## I. PETITION DESCRIPTION

Petition: 2019-0005-ARB  
 Project Name: Wellington Green MUPD "F" Outparcel F2 Building  
 Owner/Petitioner: Weingarten Realty Investors / WRI Wellington Green, LLC.  
 Agent: Lynne Raffiani  
 Project Manager: Damian Newell, Senior Planner  
 Request: The petitioner is requesting Architectural Review Board (ARB) approval of the exterior elevations, colors, materials, and site amenities for the proposed 12,000 SF Outparcel F2 retail/restaurant building located in the north portion of Wellington Green MUPD "F."

Elevations/Architectural Details, Colors and Materials Drawing

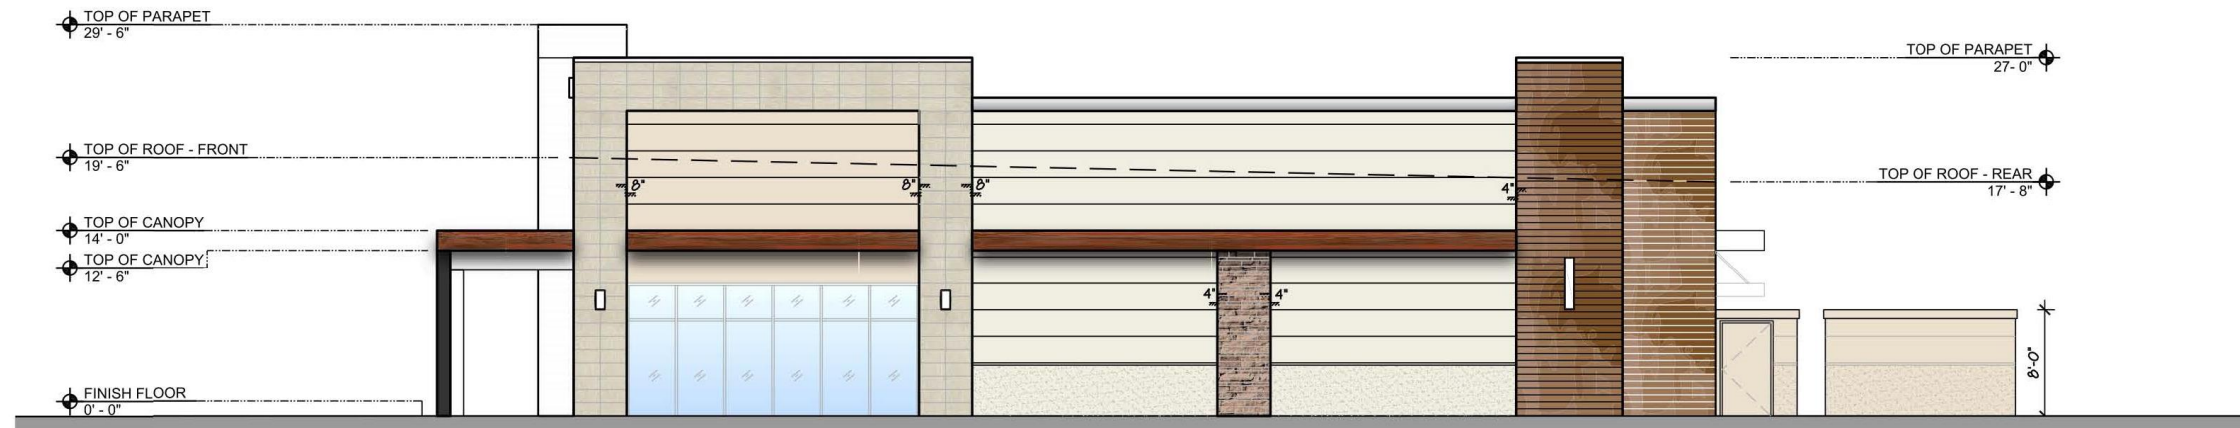
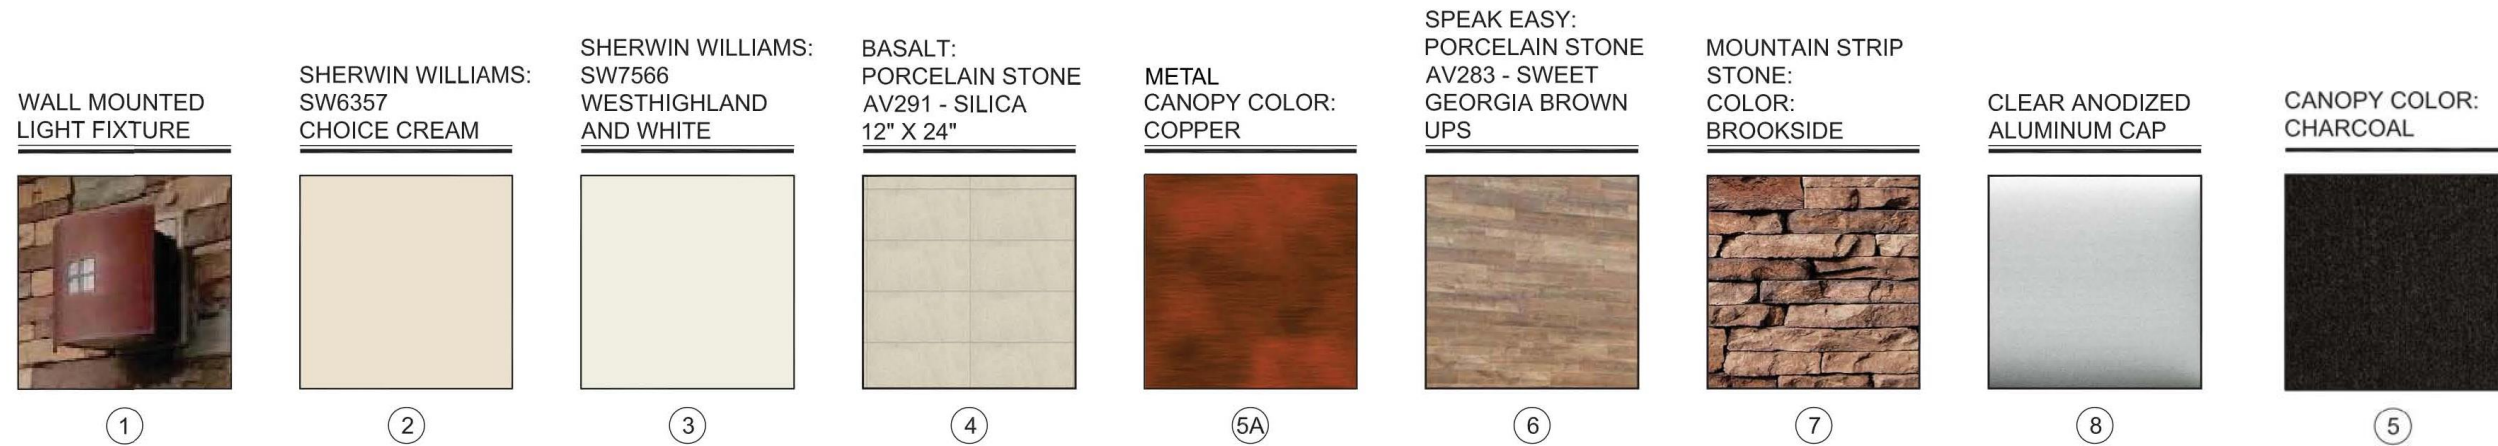
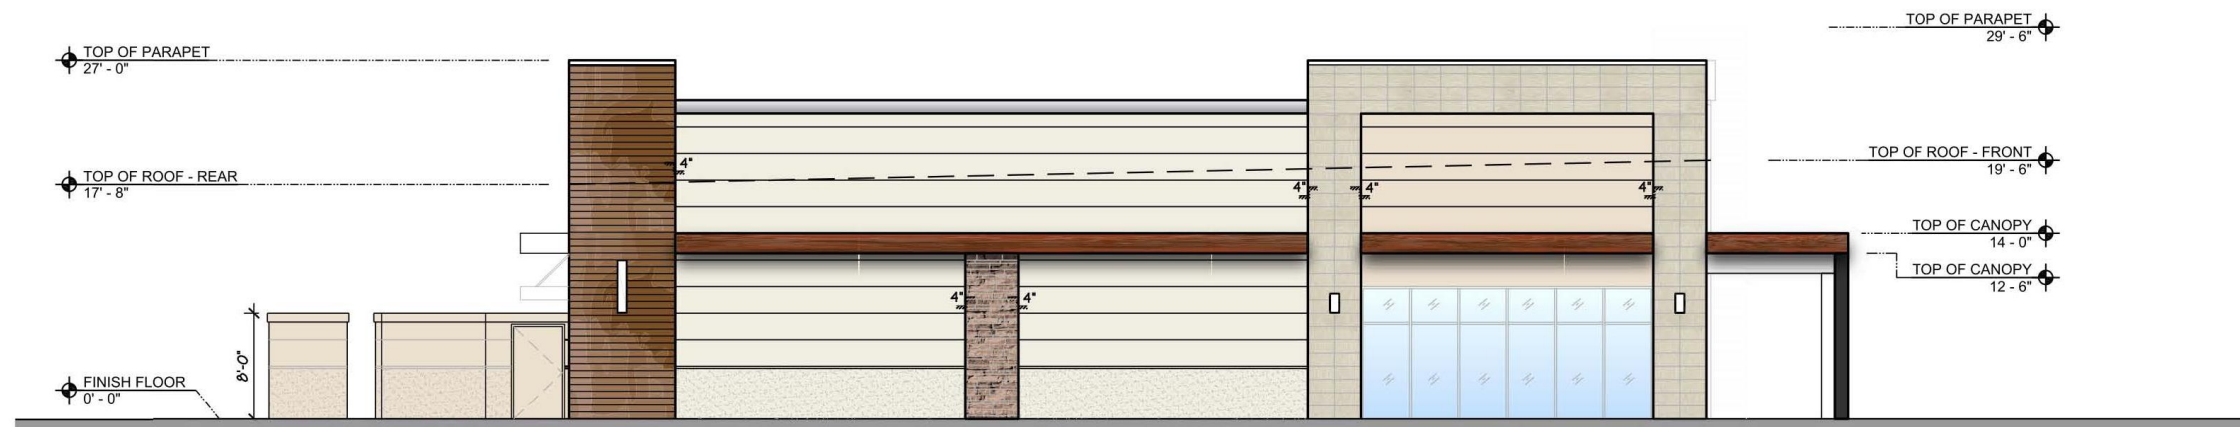
The elevations/architectural details, colors and materials drawings illustrate (Page 2 and 3) a proposed one-story building with a parapet wall height of 27' – 0", smooth stucco finished walls with accent stone veneer, aluminum parapet wall cap, and metal canopy/awning. The building has consistent architectural details and projections on all façade with metal canopy feature that is an appropriate scale for the façade. The proposed exterior color/material palette (Page 2 and 3) was reviewed for consistent/compatibility with the surrounding area and Wellington's approved ARB Color Chart. The proposed color palette indicates the base color schemes as Choice Cream SW6357. The accent color schemes is Westhighland White SW7566 with accent porcelain stone (AV291-Silica and AV283-Sweet Georgia Brown UPS), and stone veneer (Mountain Strip-Brookside). The wall mounted light fixture color is copper. The accent parapet wall cap is anodized aluminum, and metal canopy/awning color is copper with charcoal color support structures (columns/cables). The applicant did provide a color for the glass glazing or window frame. Staff recommends the color be the same as the in-line building glass glazing and window frame color within MUPD "F." The fencing/railing, site furniture, trash receptacle, bike rack, etc., will be finished in black.

**Response:** The proposed building has projections and recesses with frontage along State Road 7 /US 441 with a horizontal length over 140 linear feet facing the east. As illustrated on the elevations (Page 2 and 3), the proposed building scale, colors, materials, design and architecture are compatible and appropriate to the character of the surrounding area.

- c) Exterior base and accent paint color finish shall be non-glossy.
  - d) The glass glazing and window frame color shall be the same as the in-line building glass glazing and window frame color within MUPD "F."

4 DUMPSTER ENCLOSURE ELEVATION  
SP2.1 SCALE: 1/4" = 1'-0"

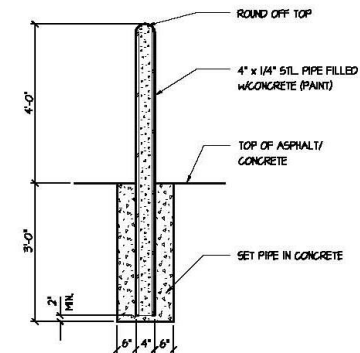
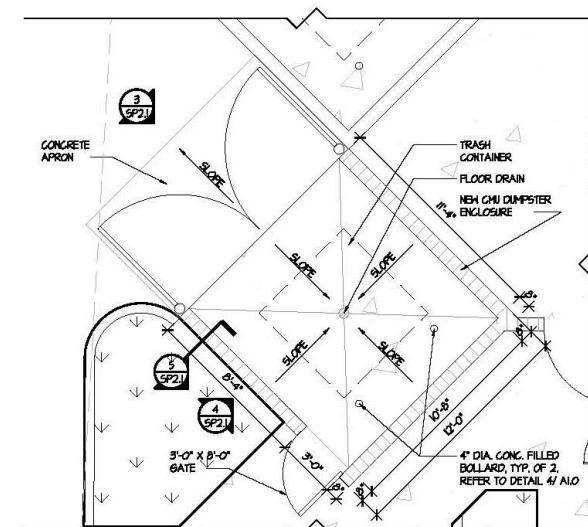
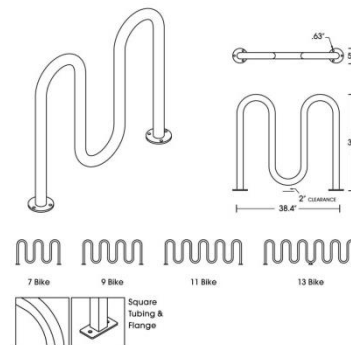
**Response:** The proposed dumpster enclosure is located along the west façade of the building, and is compatible with the color, design and style of the building.

- a) All fencing/railing, site/outdoor seating area furniture, umbrella, trash receptacle, bike rack, etc., shall be finished in black.
  - b) The dumpster(s) shall be enclosed with a stucco finished concrete wall and opaque gate that is compatible with the color, design and material of the Outparcel F2 building. The wall and gate colors shall be Choice Cream SW6357 with accent Westhighland White SW7566. The enclosure wall/gate height shall be a minimum of one (1) foot above the object being screened.
